The Lighting Quotient

DOCKETED**15-BSTD-01**

March 17, 2015

Attention: Docket No. 15-BSTD-01

Figure 1

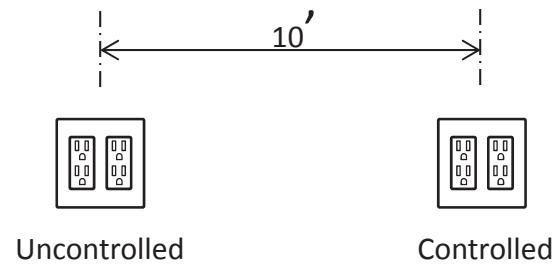
The “50%” requirement specified in ANSI/ASHRAE/IES Standard 90.1-2010 Section 8.4.2 assures that, in regulated spaces, at least one controlled receptacle is provided in addition to EACH uncontrolled receptacle installed, while the Title 24 language does not. Title 24 Section 130.5(d)2 simply requires that “*At least one controlled receptacle shall be installed within 6 feet from each uncontrolled receptacle...*” Consider the respectively compliant receptacle arrangements shown in Figures 1-4, attached.

Figure 3

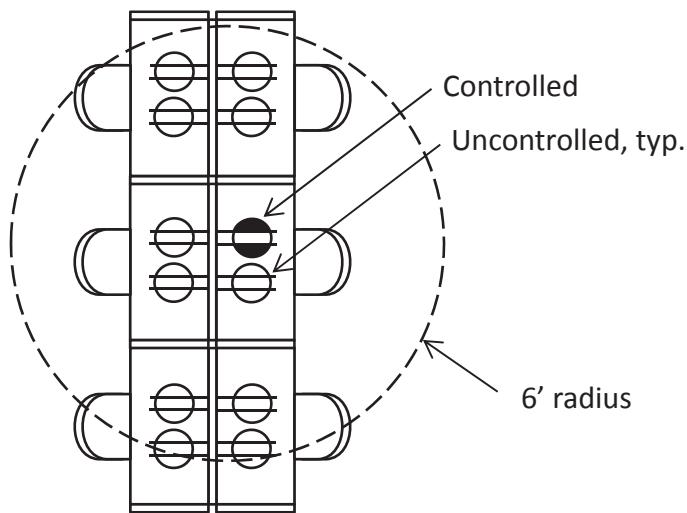
Also, as shown in Fig. 3 and Fig. 4, neither standard assures access to both controlled and uncontrolled receptacles at each workstation in open offices. Providing such access is desirable for limiting after-hours energy consumption. It should also be noted that “splitwired duplex receptacles” are generally not available for modular wiring systems deployed in open office workstations. Accordingly, the Commission may consider adding one of the following provisions:

“Where receptacles are installed at workstations in open office areas, at least one controlled receptacle shall be installed at each workstation.”

“Where receptacles are installed at workstations in open office areas, at least one controlled and one uncontrolled receptacle shall be installed at each workstation.”

Figure 7
Complies with proposed
Exception to Section 130.5(d)8

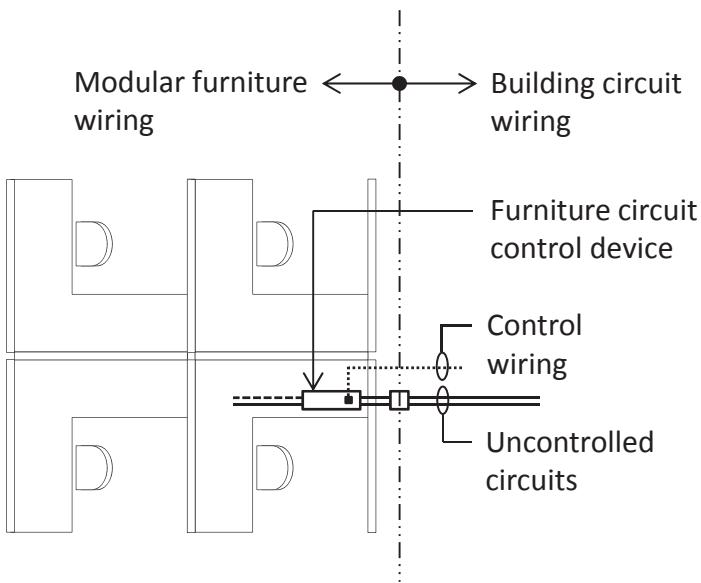
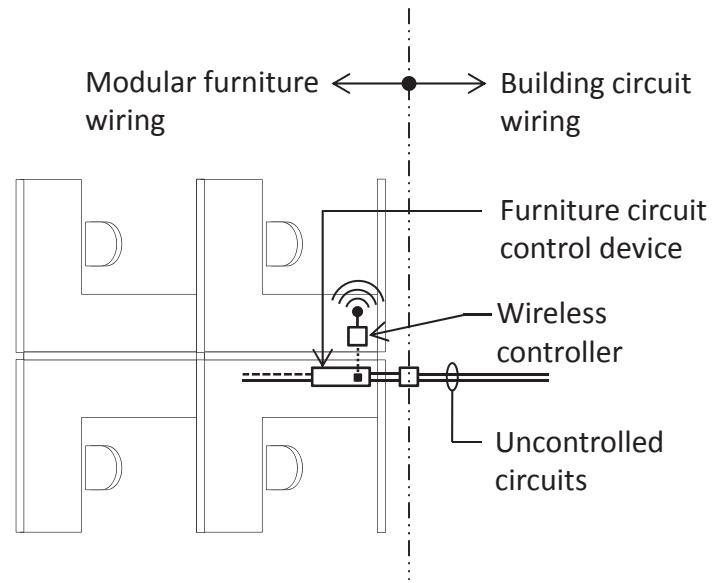
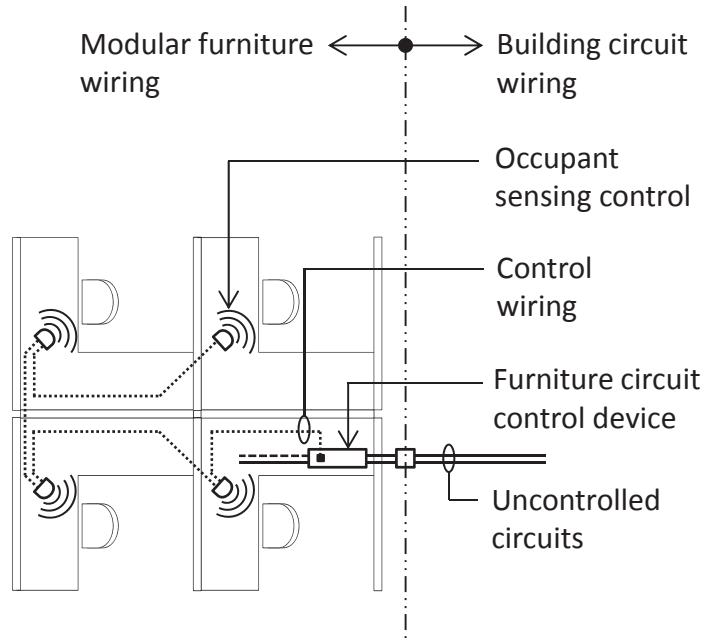
This requirement, along with EXCEPTION 1 to Section 130.5(d) discussed below, fails to acknowledge and anticipate receptacle circuit control technologies available in conjunction with the modular wiring systems supplied with open office workstation furniture. These **“furniture circuit control devices”** facilitate compliance by eliminating the need for building controlled circuits in open office areas. Furniture circuit control devices may be integrated into the furniture system modular power feed cable (as shown in Figures 7, 8, and 9, attached) or may be hardwired in-line between the furniture system and the building wiring (as shown in Figures 5 and 6, attached). Typically, they control workstation integrated receptacle circuits in response to one or more of the following control inputs:

The Commission would do well to consider an exception to Section 130.5(d)8 for furniture circuit switching devices supplied integral to modular office workstation systems. Accordingly, the Commission may consider adding the following language:

"EXCEPTION 1 to Section 130.5(d)8: In open office areas, controlled circuits are not required if, at time of final permit, workstations are installed and equipped with integral circuit control devices that provide receptacles that comply with Section 130.5(d) 1, 2, 3, 4, 5, 6 and 7."
